March 15, 2011

Subject: 2010 Rulemaking Proceeding Phase II on Appliance Efficiency Regulations
(Docket # 09-AAER-2)

Recently the California Energy Commission (CEC) held a second workshop on the topic of energy efficiency requirements for Battery Charging Systems. The CEC presented a draft Staff Report on the Staff's analysis of proposed energy efficiency requirements for these products. As a manufacturer of specialized and sophisticated non-consumer Battery Charging Systems, Motorola Solutions, Inc. (MSI) was pleased to attend the workshop and appreciates the opportunity to comment on the draft Staff Report. As small, non-consumer Battery Charging Systems are complex and vary greatly in functions and features, we understand that appropriate and effective regulation is a complex topic, and we look forward to a continuing dialogue regarding energy efficiency for Battery Charging Systems. In this letter, we offer comments on the current draft Staff Report.

Figure B4: Optimum Filter Capacitor Selection

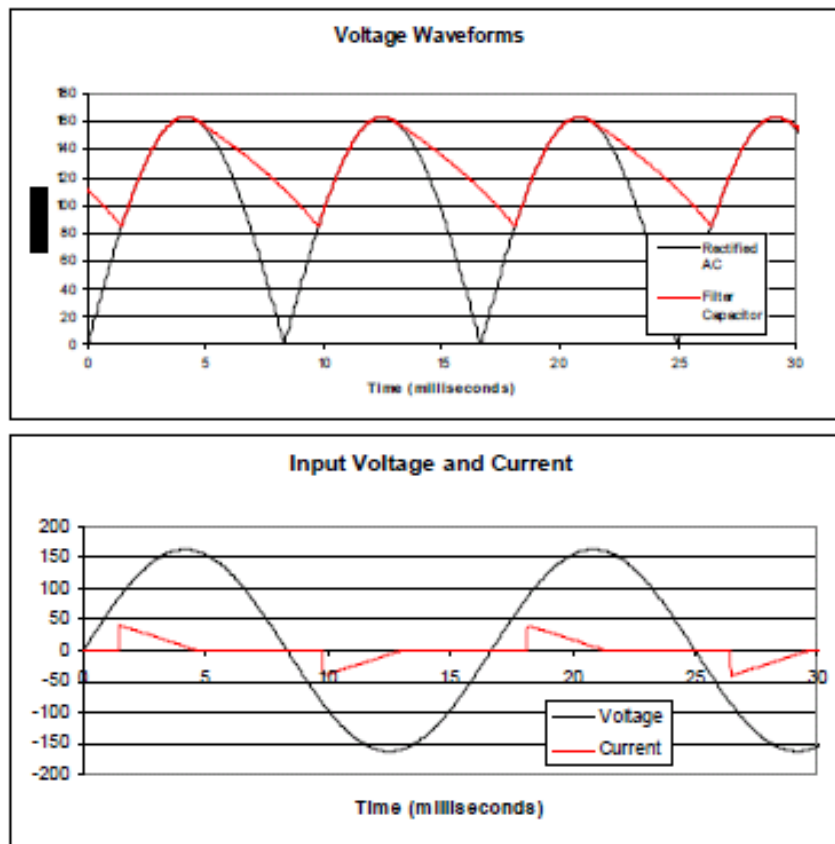
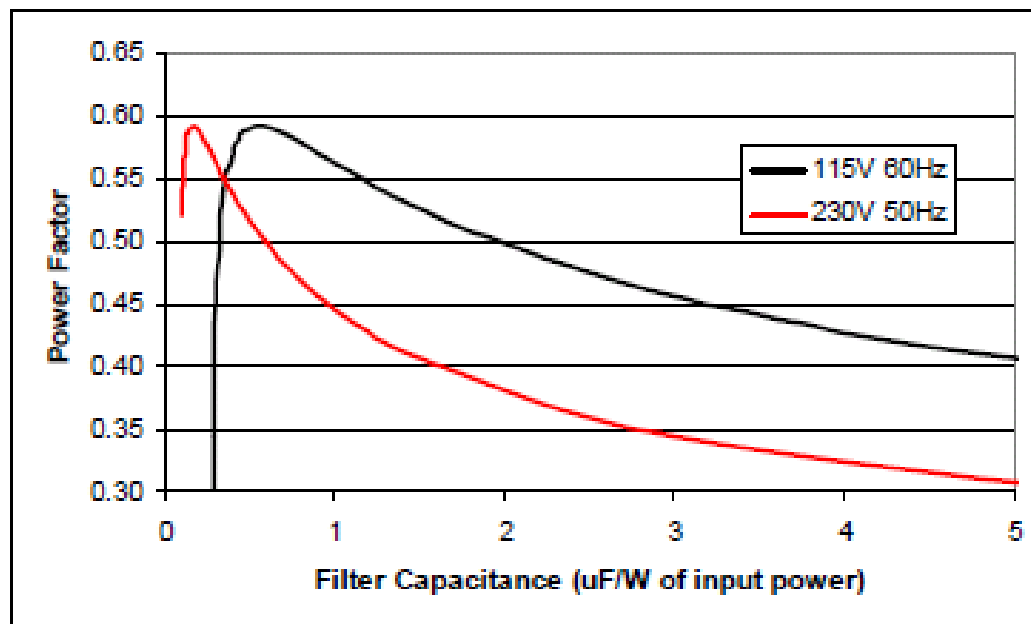
Motorola Solutions, Inc. has substantially confirmed the results¹ in Figures B3 and B4, assuming ideal rectifiers and an extremely low power supply Under Voltage Lock Out (UVLO) of 20 volts. A graph of some of Motorola Solutions, Inc.'s results is shown below. Appended to this graph are curves showing the lowest capacitor voltage reached throughout the AC power line cycle for each value of capacitance considered. An example of such variation in capacitor voltage can be seen in the top graph of Figure B3 above.

Note that Motorola Solutions, Inc. is unable to replicate the Figure 4B CASE report's 115V Power Factor values on the left end of the curve that go down to .3. This is because Motorola Solutions, Inc.'s calculations show that the power supply collapses (the capacitor voltage reaches the UVLO level) for a PF much below .48. Indeed, they are very close to zero at PF = .48.

Figure 1

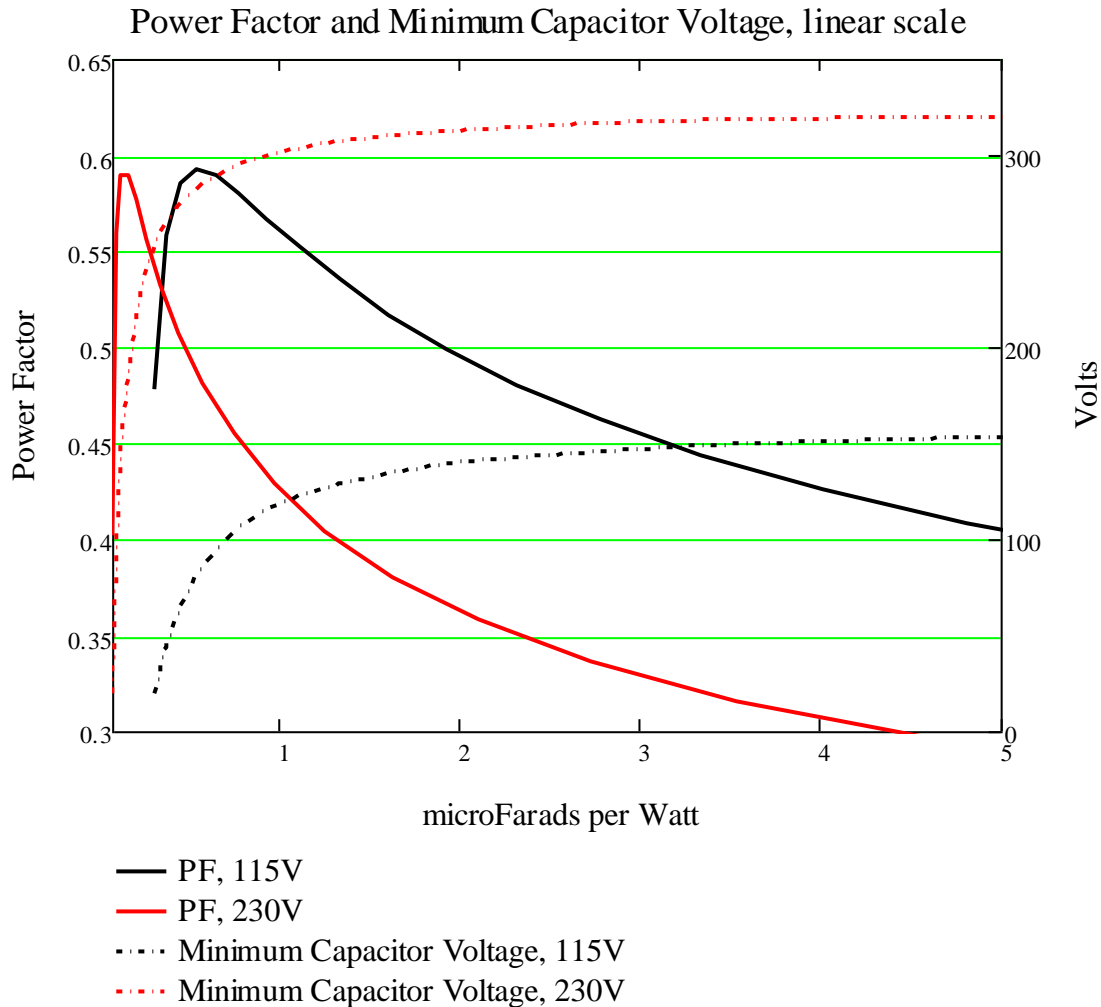
The above graph is drawn as shown for the purposes of direct comparison to Figure B4 in the Case report. It is redrawn below in a semilog format to make it easier to see the features of the curves at low capacitor values:

Figure 2

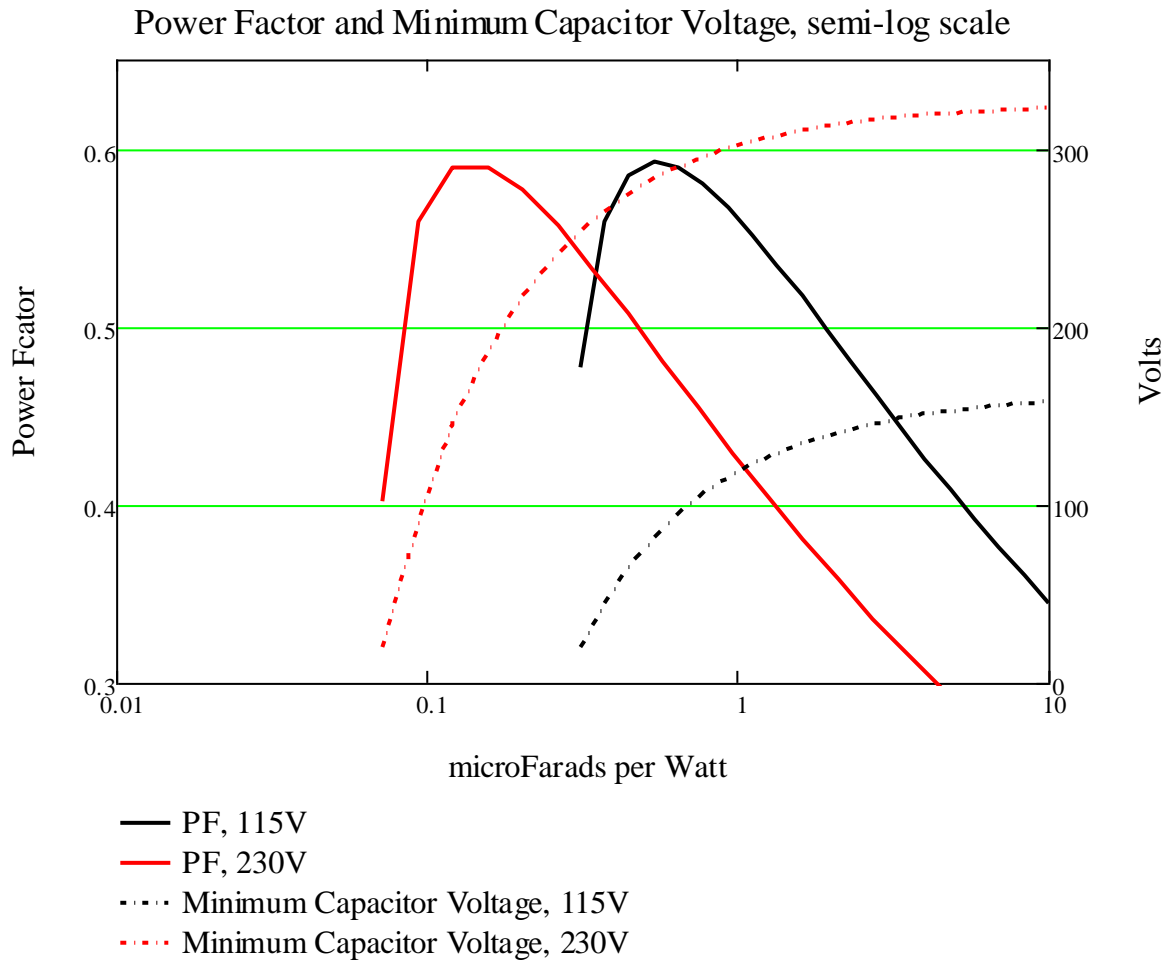
It should be noted immediately that the draft Staff Report proposes a minimum PF of .6 for all power supplies, and that neither the CASE report nor Motorola's analysis shows that this is even possible with Capacitor Sizing. Based on the CEC staff presentation made on March 3, 2011, it is MSI's understanding that the CEC has re-considered this proposal and will instead propose a minimum PF of 0.55. However, even this number is not consistent with the CASE report, which recommends a PF of 0.5 for products which will be tested at both 115V and 230V in order to be sold to the international market (CASE report section 9.2).

Figure 2 Schematic from the Reference Design Report (RDR-142) by Power Integrations

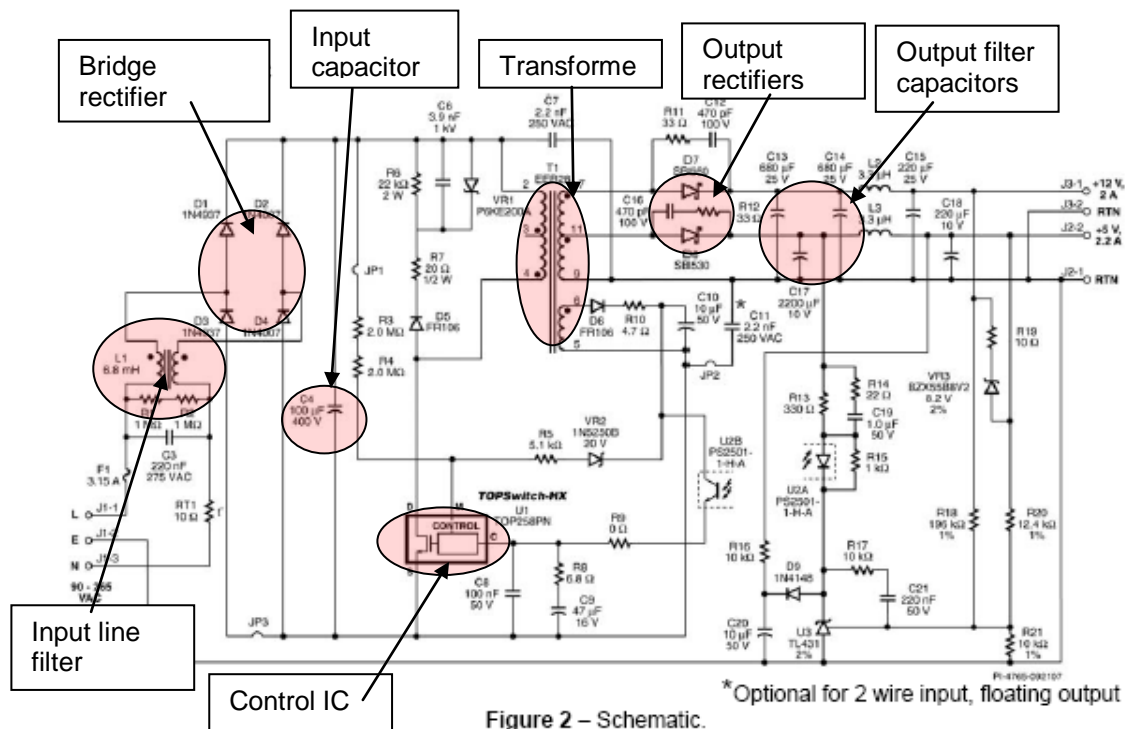
In the redesign analysis, the input capacitance was reduced from 100uF to try to meet the requirement of 0.55uF/Watt. Considering the input power of 44W, the resulting input capacitance is 24uF. ($44\text{Watt} \times 0.55\text{uF/Watt} = 24\text{uF}$)

Reducing the input capacitance to 24uF causes the minimum DC bus voltage to drop well below the minimum required voltage of 70V for control IC operation when the nominal 100VAC line voltage of Japan falls to its minimum of 90VAC. The power converter needed to be redesigned. See the results below.

The table below contains a comparison analysis between the original power supply designed for 2.3uF/Watt and a power supply designed for 1.75uF/Watt. 1.75uF/Watt was chosen because this control IC will not continue to operate when the capacitance level falls below 1.75uF/Watt. Unfortunately, this change to the minimum possible input capacitance commensurate with controller IC operation does not meet the minimum Power Factor requirement of .55.

Referencing the above results for 1.75uF/Watt, this analysis clearly demonstrates a trend of significant increase in both primary and secondary currents. From the established trend above, an input capacitance reduction to 0.55uF/Watt would necessitate significant changes to the following components:

- 1.) Transformer: (inductance, capacitance, wire size, core and turns ratio)
- 2.) Secondary rectifiers: (change to higher current low-loss parts)
- 3.) Secondary capacitor filters: (change to higher current low-ESR parts)
- 4.) Input line filter: (change common-mode filter design for higher current)
- 5.) Input capacitor filter: (needs to be lower ESR due to higher currents)
- 6.) Possible additional EMI filtering due to increased current amplitude.
- 7.) Controller IC (change this part)

Figure 2 Efficiency of NiCd battery charge cycle

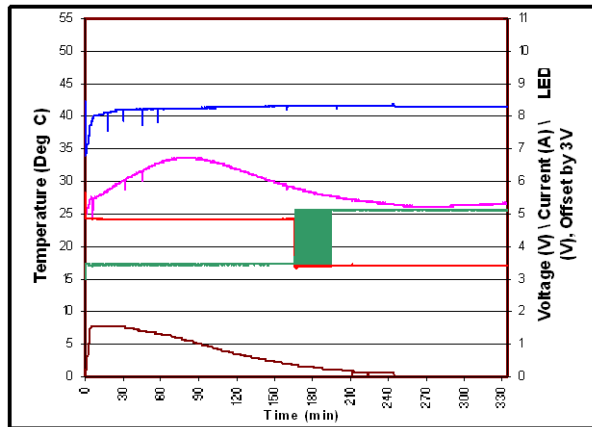
In the response to comment 15, the CEC draft Staff Report states “It is feasible to meet the proposed regulations with any battery chemistry.” While this is technically true, it is misleading to imply that the burden of compliance is the same across the various battery chemistry types, due to the inherent differences in efficiency that are exhibited during charge. Nickel batteries naturally have higher loss during recharge. Note the figures below 2 and 3 which show the difference in charging efficiency between a typical NiCd battery used by MSI and a typical Lithium Ion battery used by MSI.

Not accounting for this fundamental difference in the efficiency requirements places significant additional burden on the charging solution for Nickel chemistry batteries. By not acknowledging the fundamental difference in chemistries, the CEC proposal instead of being neutral, is far more restrictive of nickel batteries. This will require these types of chargers to undergo more extensive design changes which will result in much higher costs and cycle times to get compliant designs to the market. This would mean increased selling prices to mission critical customers, and could result in product unavailability or shortages. It would be far more appropriate to differentiate the proposed energy efficiency requirements based on battery chemistry, or alternatively to raise the proposed limits for each mode across the board.

Figure 4

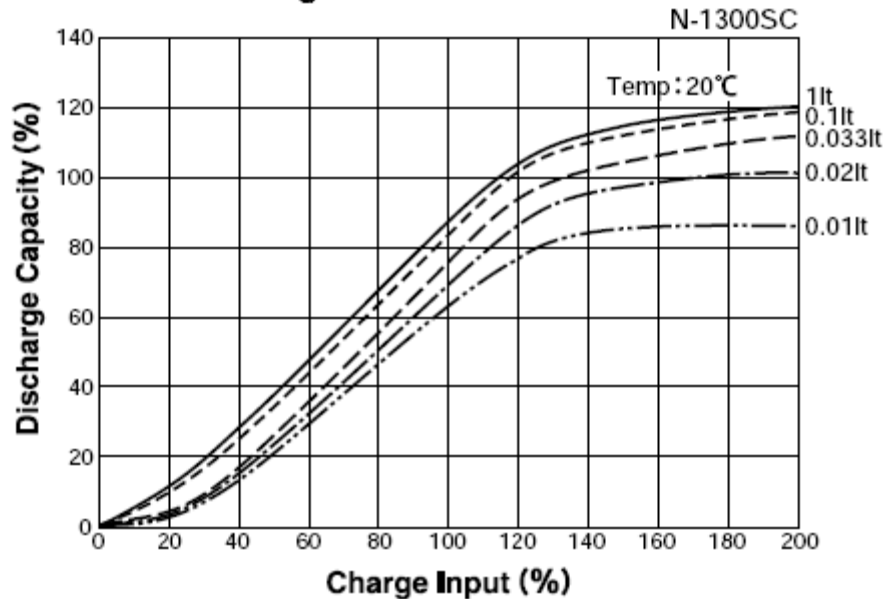
Another assumption made in both the CASE report and the draft Staff Report is that rapid charging is inherently less efficient than slow charging (see page 15, one of the "methods that can lead to higher efficiency in battery chargers" is listed as "lower current rate for charge and discharge cycles"). It is clear that the proposed limits on energy consumption in the various modes were developed with this assumption in mind. However, this is simply not true for all battery chemistries. In figure 4 below, which is taken from the battery cell manufacturer Sanyo's website, a charge efficiency graph for a typical NiCd battery is shown. As described in the Sanyo documentation, the graph shows that "...the charge efficiency as well as the output capacity is lower at a lower charge rate."

For NiMH batteries, charging at a low rate would be contrary to the manufacturer recommendations and would actually be detrimental to the product in that the battery life would be shortened. Again, documentation from the battery cell manufacturer Sanyo states: "Overcharging shortens the service life of the Twicell*, and for this reason, low-rate charging is fundamentally not suitable."
